# TECHNISCHE INFORMATION NR. SI 36-130

## SERVICE INFORMATION NO. SI 36-130

### Inspection and/or replacement of expansion tank assy. for ROTAX® 912, 914, 912 i, 915 i and 916 i (Series) Aircraft Engines

ATA System: 75-20-00 Expansion Tank

Fig. 1

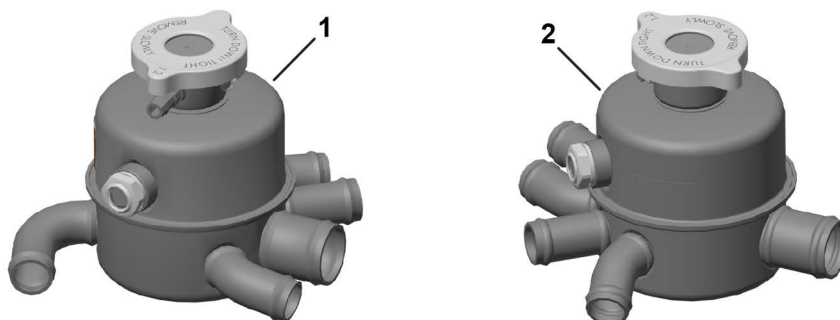
Fig.1/ pos.	part no.	Qty/ engine	Description
1	922668	(1)	EXPANSION TANK ASSY.
2	922666	(1)	EXPANSION TANK ASSY.
-	-	AR	COOLANT (as specified in the latest Service Instruction SI-912-016, SI-914-019, SI-912 i-001, SI-915 i-001,SI-916 i-001)

Fig. 5: GOOD Welding – total view / GOOD Welding – side view

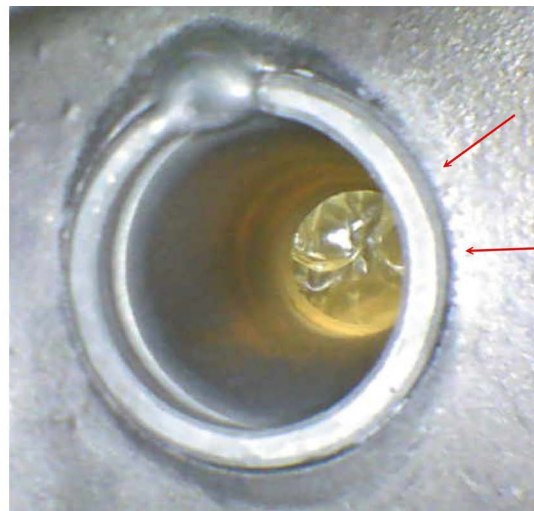
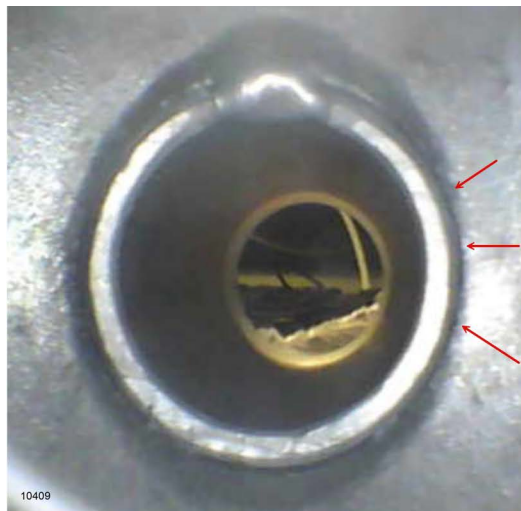
Step	Procedure
1	Remove the radiator cap from the expansion tank.
2	Perform an internal visual inspection using a bore-scope or similar device.
3	If the visual inspection shows consistent welding, the expansion tank assy. is serviceable (See Fig. 5), continue with section 3.6). <b>NOTE:</b> Welding must be present and contiguous around every connection.
4	If the visual inspection shows any connection with inconsistent or missing welds, the expansion tank assy. is unserviceable and must be replaced (See Fig. 6).
5	Apply small amount of coolant to rubber surfaces inside radiator cap (provides lubrication to prevent binding). Tighten the radiator cap by hand.
